RFP Title: Classical High School Campus Electrical Upgrades

Addendum #: 2

Addendum #2

Project: Classical High School 770 Westminster St., Providence, RI 02903

Website: www.StudioJAED.com
Email: info@StudioJAED.com

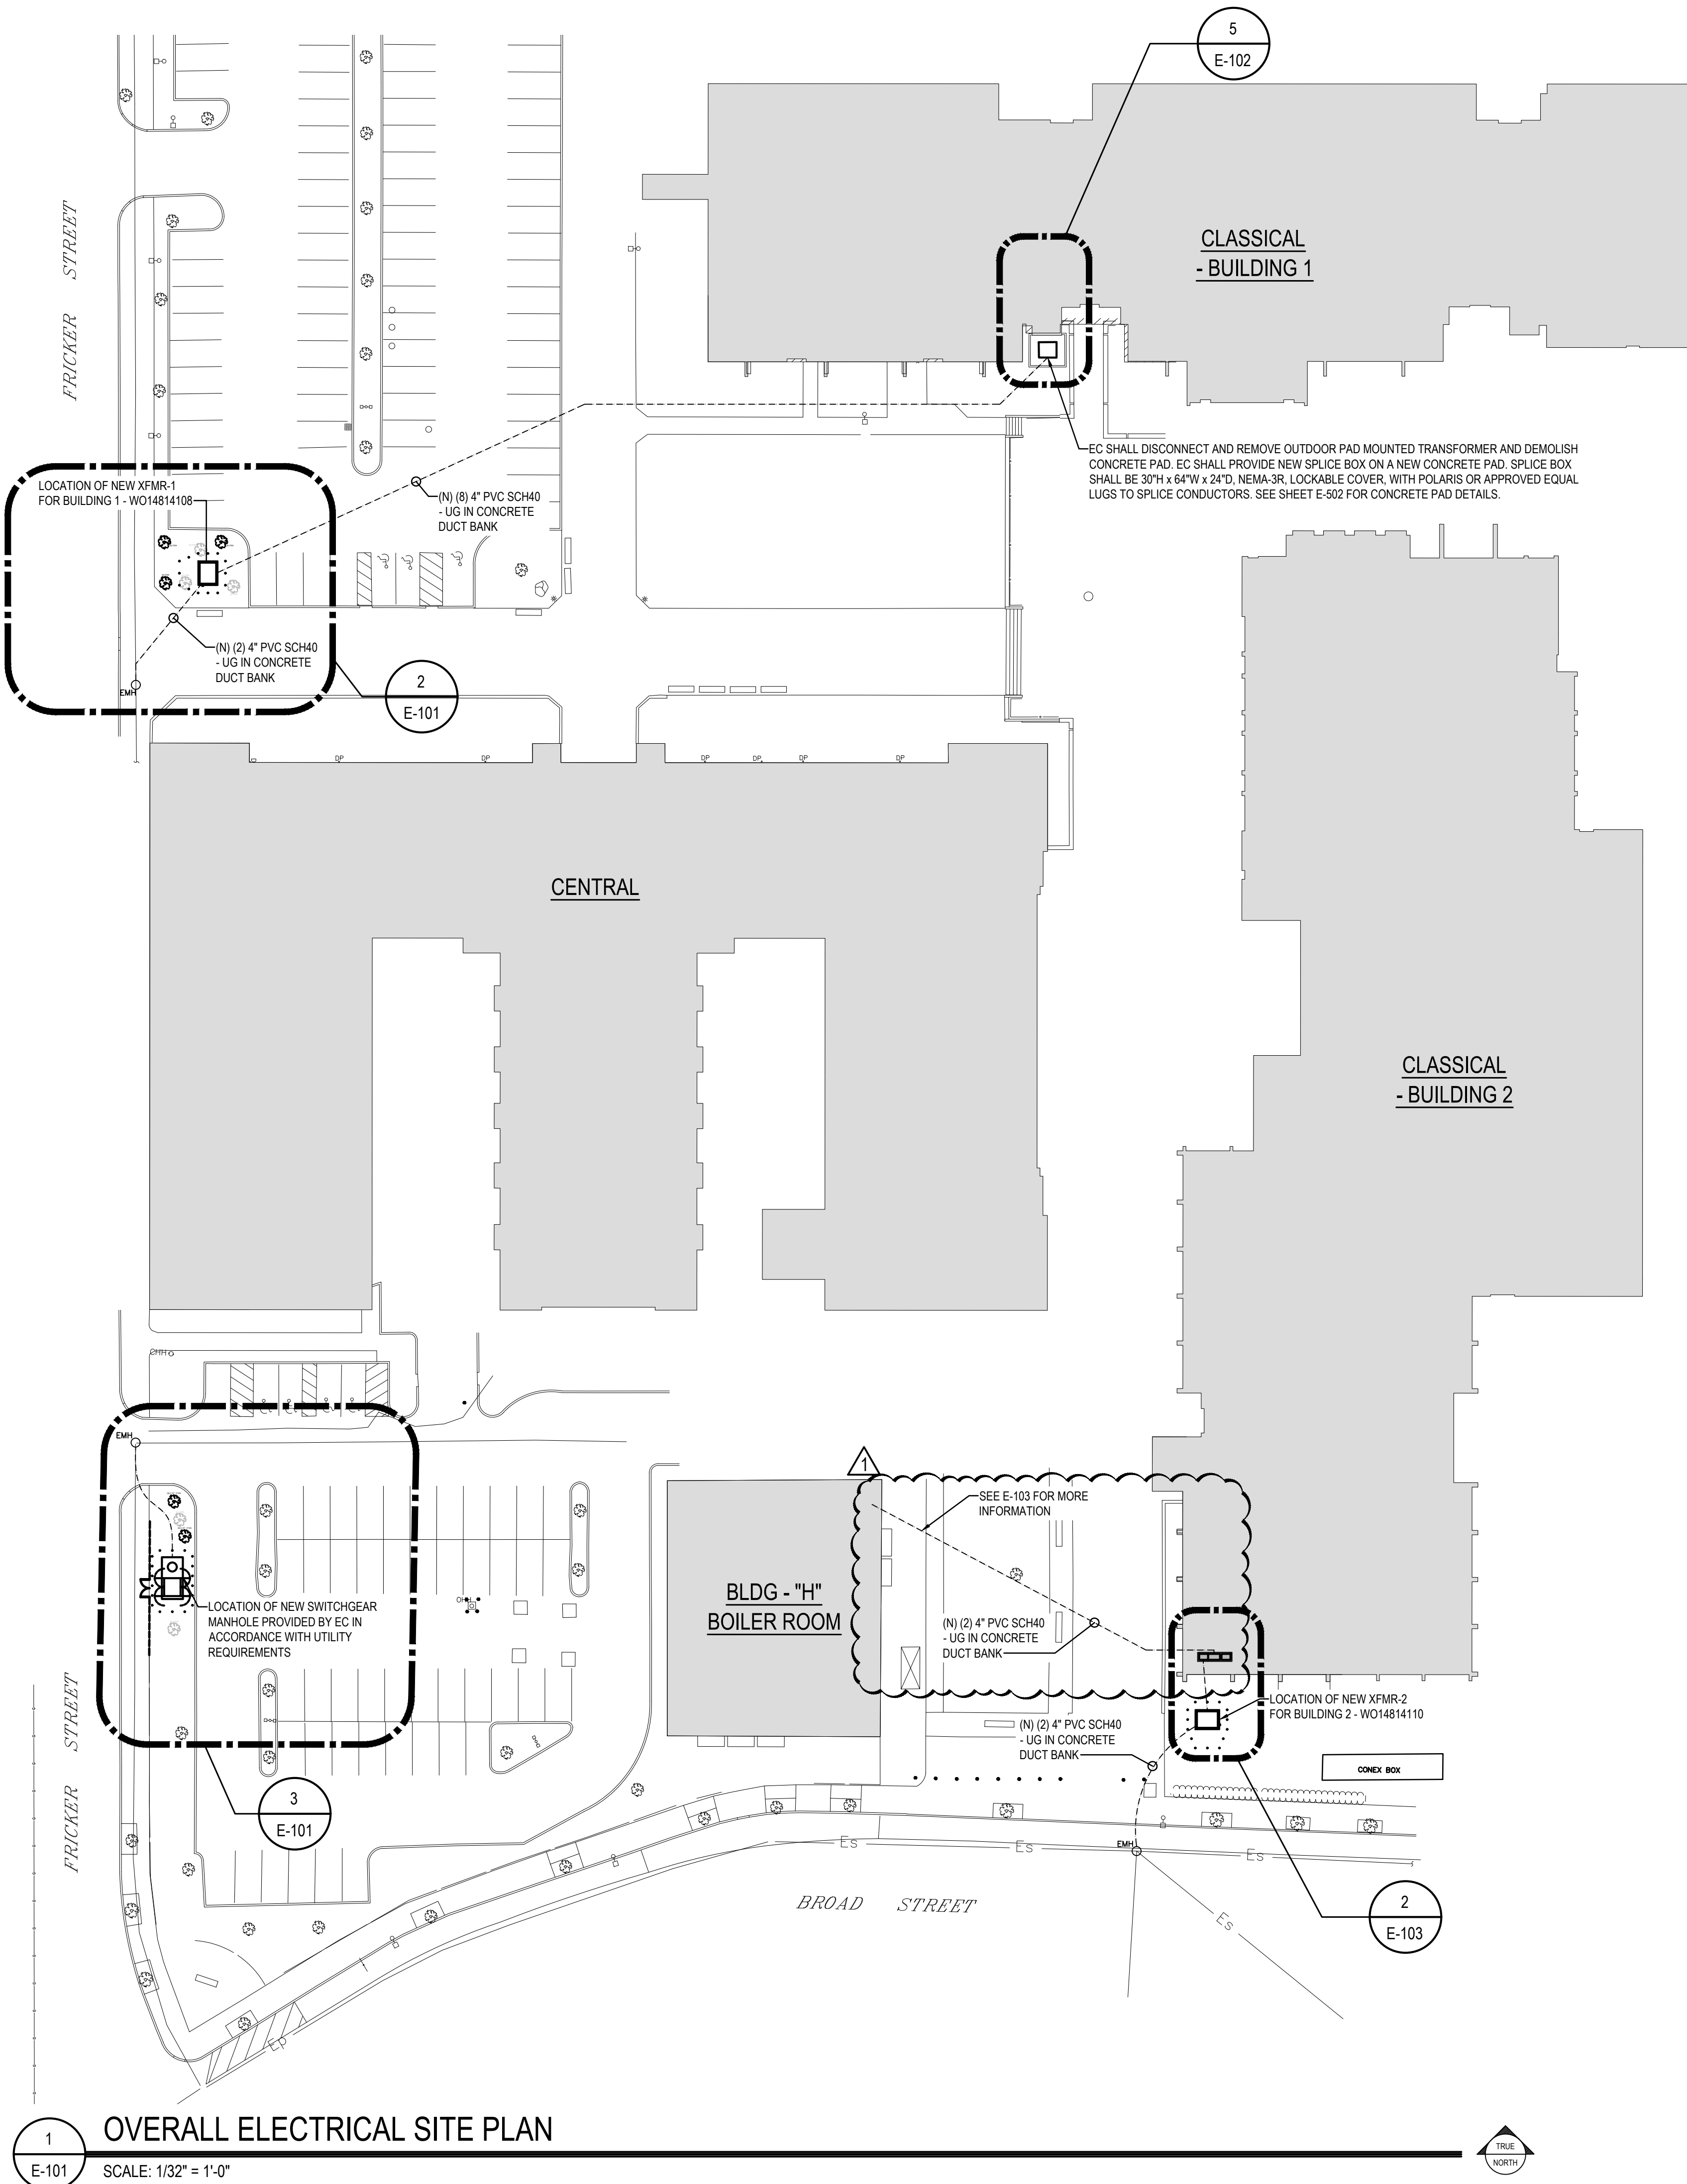
- 1. *Drawing E-101*
 - a. Identified additional scope in Building H.
- 2. *Drawing E-102*
 - a. Moved enlarged plans associated with Building 2 to sheet E-103.
 - b. Added a demolition plan of the basement of Building 1.
 - c. Added a DVR and a new 1200A panel PH1 to the new plan of the basement of Building 1.
- 3. *Drawing E-103*
 - a. Added this sheet.
 - b. Moved enlarged plans of Building 2 to this sheet from E-102.
 - c. Added Building H demolition and construction plans.
 - d. Added pullbox locations to Building 2 plans.
 - e. New housekeeping pad added.
 - f. Added new Distribution Section to **(N) SWBD-1.**
- 4. *Drawing E-502*
 - a. Added the housekeeping pad detail.
- 5. *Drawing ED601*
